# Comments and proposals regarding SC-FEC sublayer lane alignment process

In support of comments: 52, 54, 62, 63, 66, 67, 68

Leon Bruckman (Huawei)

IEEE P802.3ct Task Force, Geneva, January 2020

# Lane alignment verification state machine

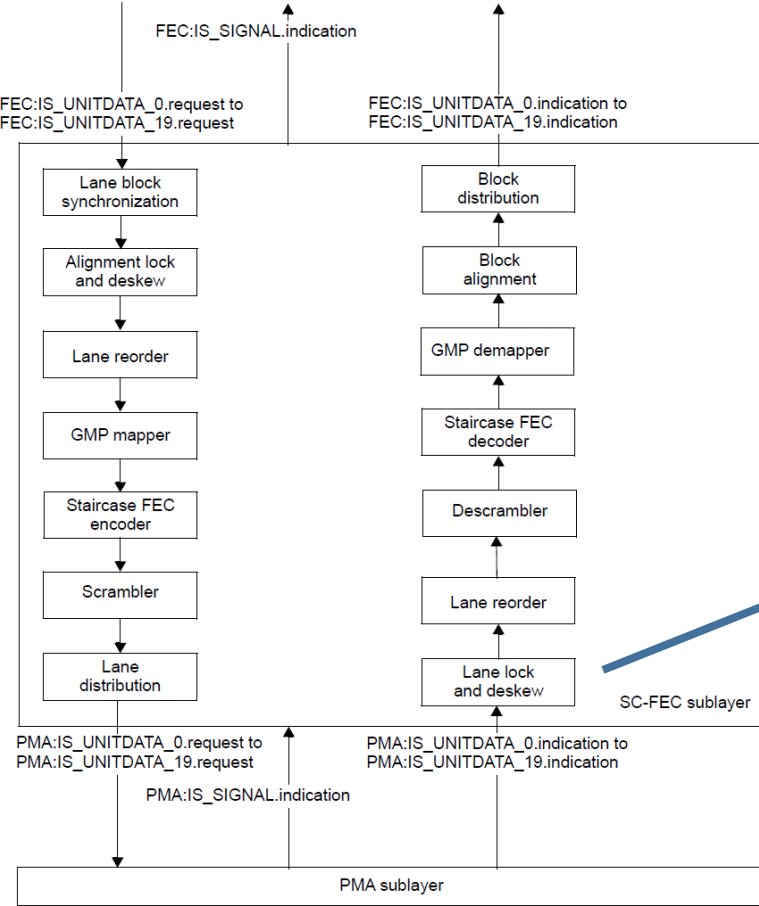
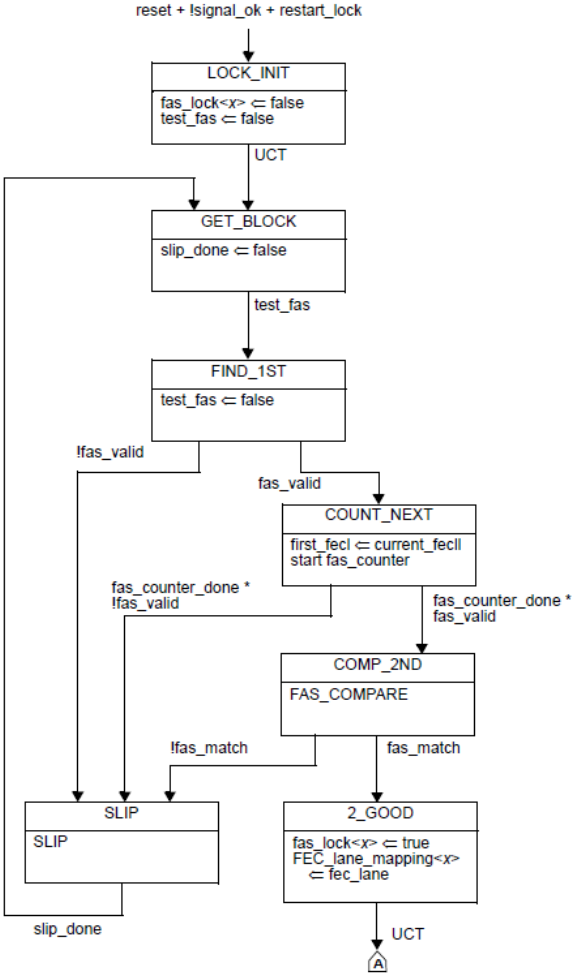
- Boolean variable that is set to true if the received 6-octet sequence is a valid frame alignment signal. The frame alignment signal consists of 40 known bits and 8 variable bits. *The sequence is considered to be valid if four of the first five octets match the known bits of the pattern described in 153.2.3.2.4, and the 6th octet represents a numerical value in the range 0 to 239 with the most-significant bit transmitted first.*

- This function compares the values of first\_fec1 and current\_fec1 to determine if a valid frame alignment sequence has been detected and returns the result of the comparison using the variable fas\_match. fas\_match is true if **fas\_valid** is true for first\_fec1 and current\_fec1, and the 6th octet of first\_fec1 (interpreted with the most significant bit transmitted first) modulo 20 is equal to the 6<sup>th</sup> octet of current\_fec1 (interpreted with the most significant bit transmitted first) modulo 20. Otherwise, fas\_match is false.

- This means that the FEC:IS\_SIGNAL.indication is set FAIL if any of the lanes losses alignment and as a consequence the FEC:IS\_UNITDATA\_i.indication primitives become undefined.

- Alignment detection based on 4 fixed FAS bytes OK
- Alignment loss detection based on: 3 fixed FAS bytes not OK
  - Configurable loss verification duration
- Separate Lane marker procedures from alignment procedures
  - Configurable detection and loss verification duration
- Maintain frame start position during loss of alignment
- Integrate anomaly before applying consequent actions
- Option to synchronize lane marker counter to MFAS
- Advantage:
  - Developers will be able to reuse the same functions/hardware they developed for other OTN similar signals.

# Lane alignment loss verification state machine

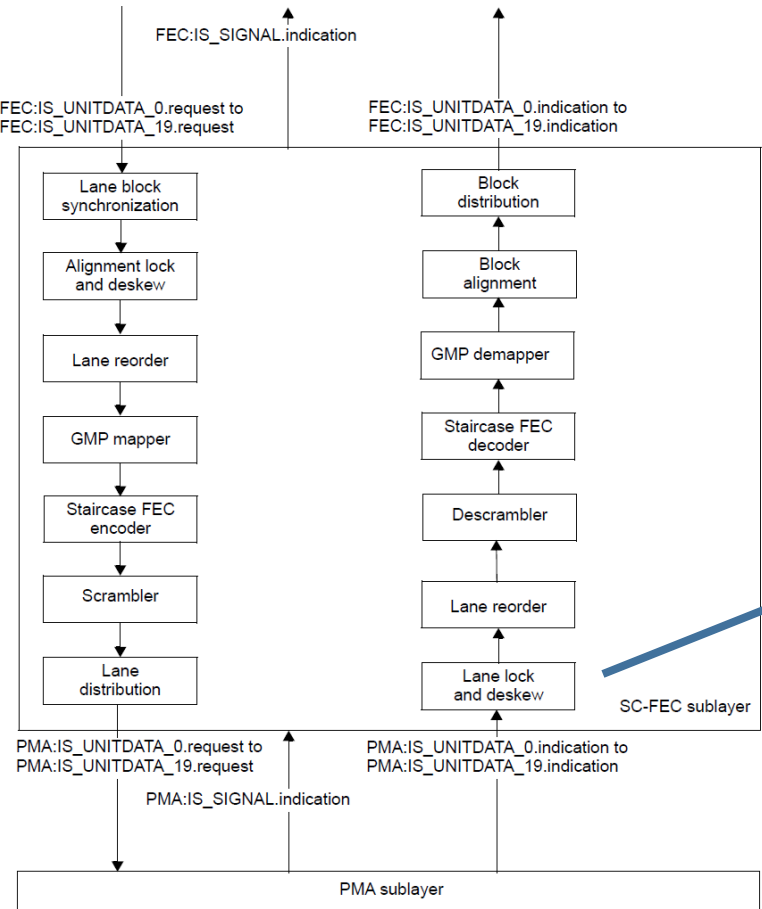
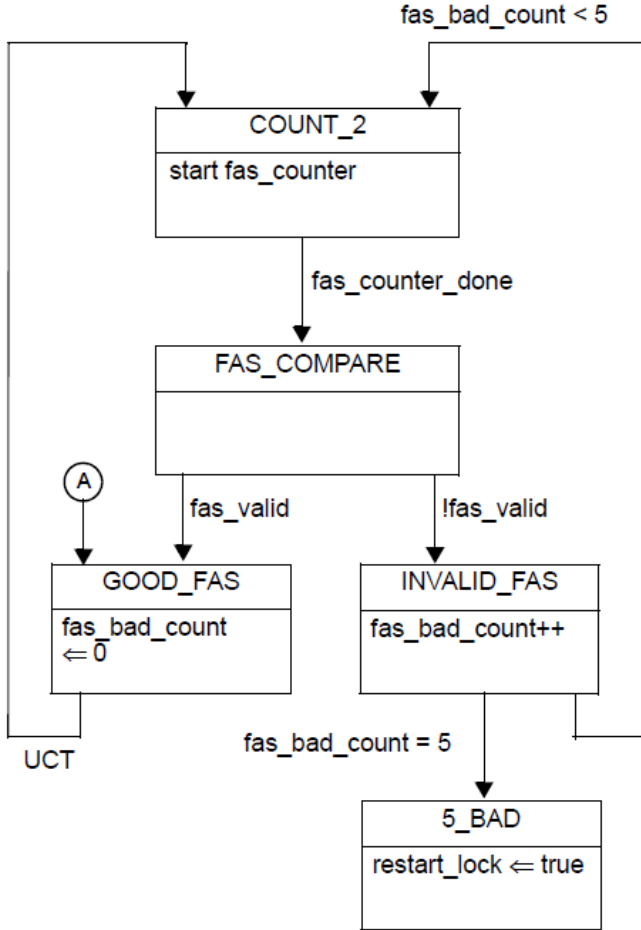
- The SIGNAL\_OK parameter of the FEC:IS\_SIGNAL.indication primitive can take one of two values: OK or FAIL. The value is set to OK when the FEC receive function has identified codeword boundaries as indicated by **fec\_align\_status** equal to true. That value is set to FAIL when the FEC receive function is unable to reliably establish codeword boundaries as indicated by **fec\_align\_status** equal to false. When SIGNAL\_OK is FAIL, the rx\_bit parameters of the FEC:IS\_UNITDATA\_i.indication primitives are **undefined**.

- **fec\_align\_status**: A variable set by the FEC alignment process to reflect the status of FEC lane-to-lane alignment. Set to true when all lanes are synchronized and aligned and set to false when the deskew process is not complete.

# Loss of synchronization probability

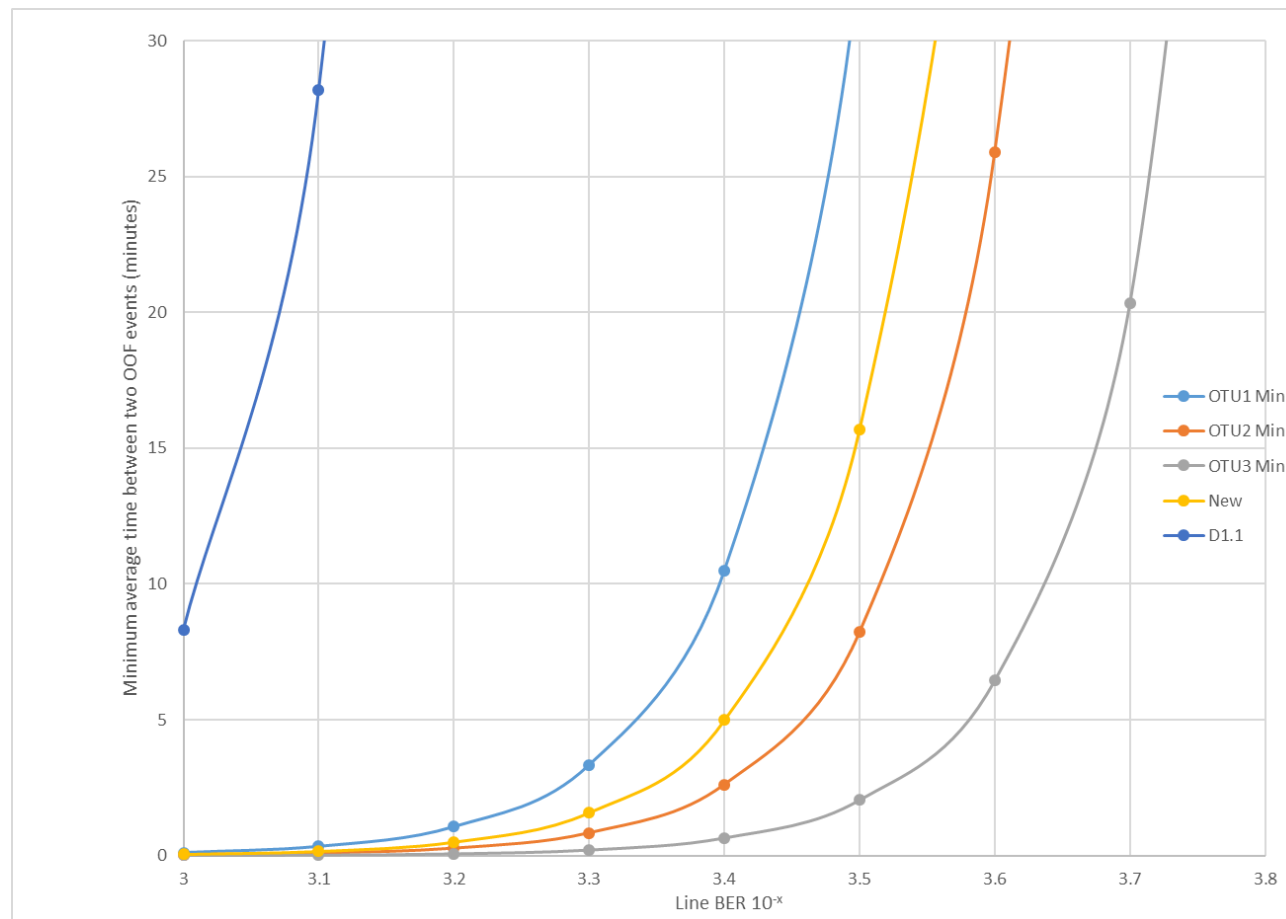
- According to D1.1:
  - Per Lane: On average there will be an alignment loss every: ~ 1.5 min
- With the new proposed loss of alignment procedure (Y is the number of consecutive verification failures to lose alignment):

- In both cases, since the alarm is not integrated, the data path may be impaired.

Y=5	Y=6	Y=7
Per Lane [sec]	1.81	17.25	163.95

# Mean time to false frame acceptance (MTTFFA)

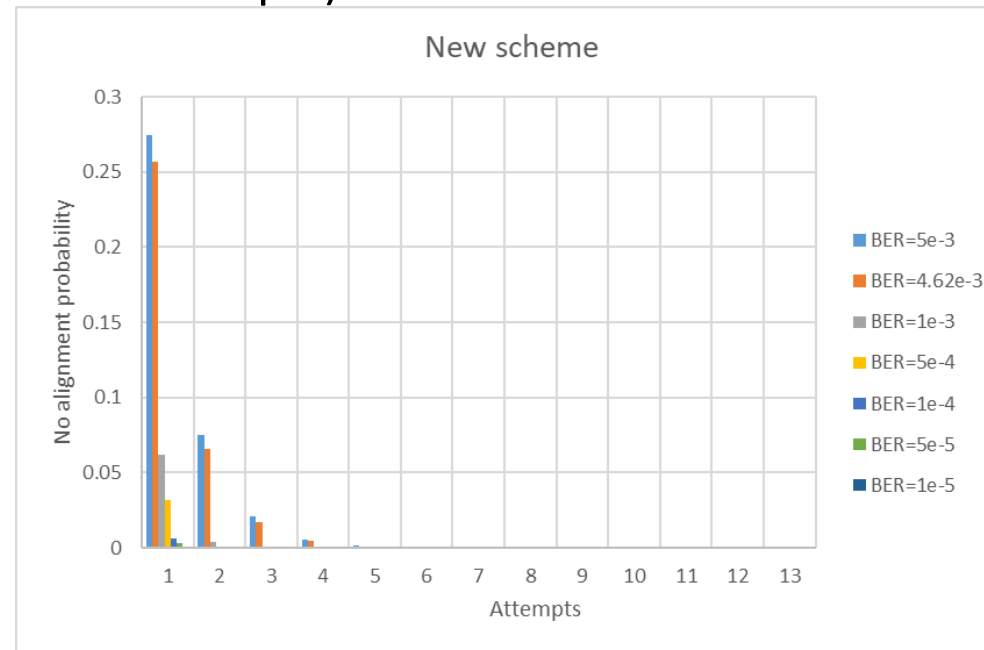
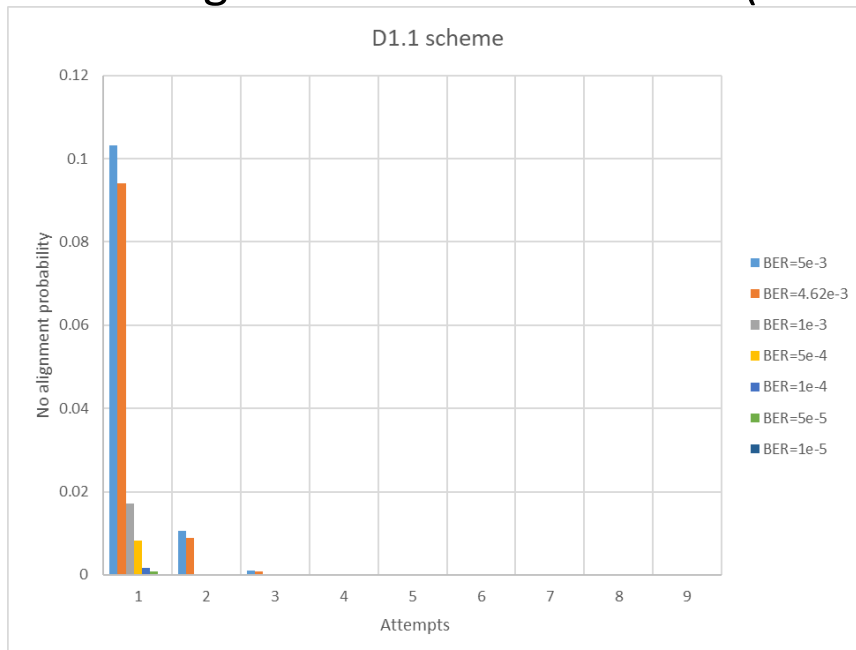
- According to ITU-T G.798 Appendix III:
  - The probability for false in-frame alignment can be obtained noting that the FAS is searched for up to one frame (FL bit long) with FL-1 possibilities for a false (simulated) FAS and confirmed the following  $\delta$  frames.
  - The equation for computing MTTFFA is:  $T_{\text{frame}} / (P_{\text{fOOF}} \times P_{\text{fIF}})$

OTU1	OTU2	OTU3	New	D1.1
MTTFFA (years) (BER = $5 \times 10^{-3}$ )	$1.173 \times 10^7$	$2.920 \times 10^6$	$7.268 \times 10^5$	$5.593 \times 10^6$	$1.144 \times 10^7$
MTTFFA (years) (BER = $1 \times 10^{-3}$ )	$2.918 \times 10^{10}$	$7.265 \times 10^9$	$1.809 \times 10^9$	$1.392 \times 10^{10}$	$1.023 \times 10^{11}$

# Alternative simpler alignment loss scheme

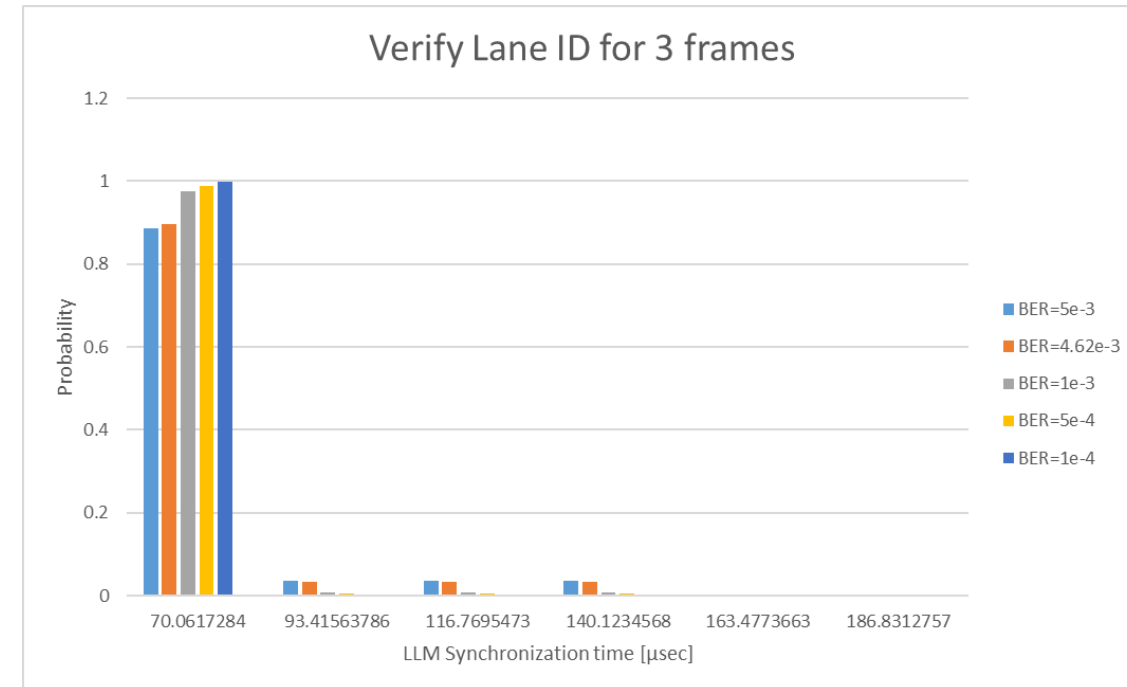
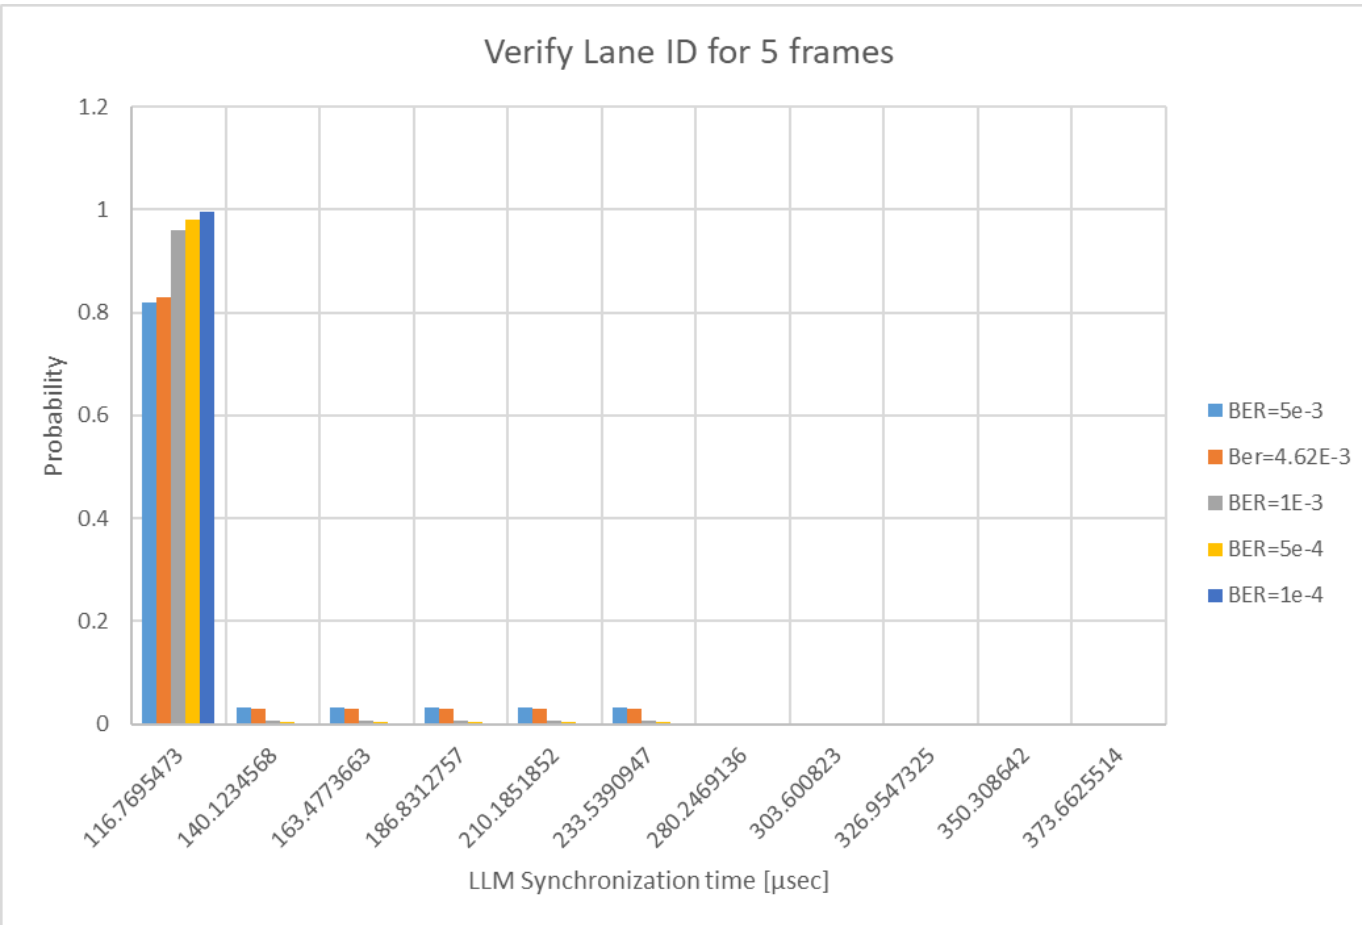
- `fas_valid`
  - Boolean variable that is set to true if the received 5-octet sequence is a valid frame alignment signal. The frame alignment signal consists of 40 known bits. The sequence is considered to be valid if a subset of 4 octets match the known bits of the pattern described in 153.2.3.2.4.
- `FAS_COMPARE`
  - This function compares the values of `first_fec1` and `current_fec1` to determine if a valid frame alignment sequence has been detected and returns the result of the comparison using the variable `fas_match`. `fas_match` is true if the third, fourth and fifth octets match the known bits of the pattern described in 153.2.3.2.4. Otherwise, `fas_match` is false.
- Option: Configurable `fas_bad_count`.

# Loss of synchronization probability – D1.1

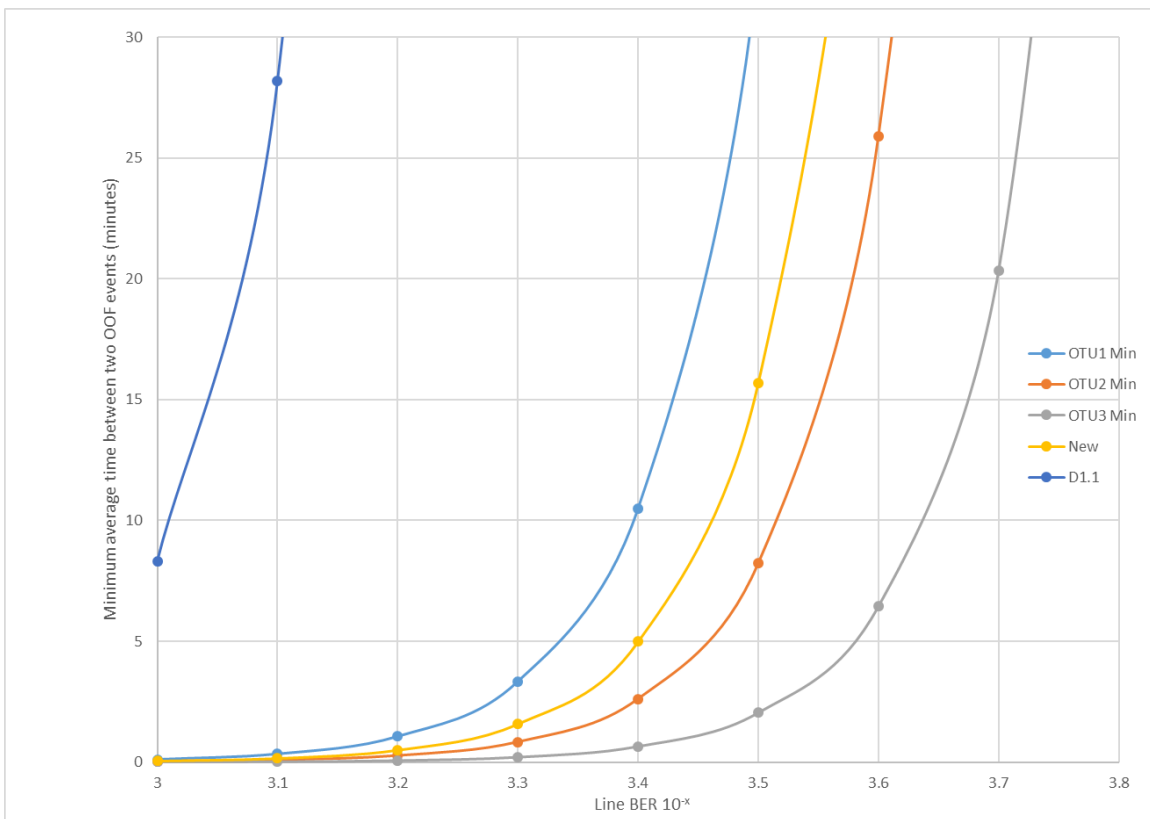
- FAS byte OK:  $(1-4.62 \times 10^{-3})^8 = 0.963632$
- FAS byte errored:  $= 1 - 0.963632 = 0.036368$
- Loss of synchronization happens if for 5 consecutive times, more than 4 out of 5 FAS bytes are errored and/or the lane ID byte is errored.

- All FAS bytes OK and lane ID OK:  $0.963632^5 \times 0.963632 = 0.800696$
  - 4 out of 5 FAS bytes OK and lane ID OK =  $C(5,4) \times (0.963632)^4 \times 0.036368 \times 0.963632 = 0.951789$

- The probability of less than 4 out of 5 FAS bytes OK or lane ID error =  $1 - 0.951789 = 0.048211$ 
    - The probability that the above happens 5 consecutive times is:  $0.048211^5 = 2.60455 \times 10^{-7}$

- There are  $4080 \times 8 \times 4 / ((255/227) \times (4.97664 \times 10^9)) = 42819.38326$  frames/sec
  - Per Lane: There will be an alignment loss every:  $1 / (2.60455 \times 10^{-7} \times 42819.38326) \sim 1.5$  min

- Per 20 Lanes: There will be an alignment loss every:  $\sim 4.48$  sec
- With the new proposed loss of alignment procedure there will be an alignment loss every:

Y=5	Y=6	Y=7
Per Lane [sec]	1.81	17.25	163.95
Per 20 Lanes [sec]	0.024	0.17	1.24
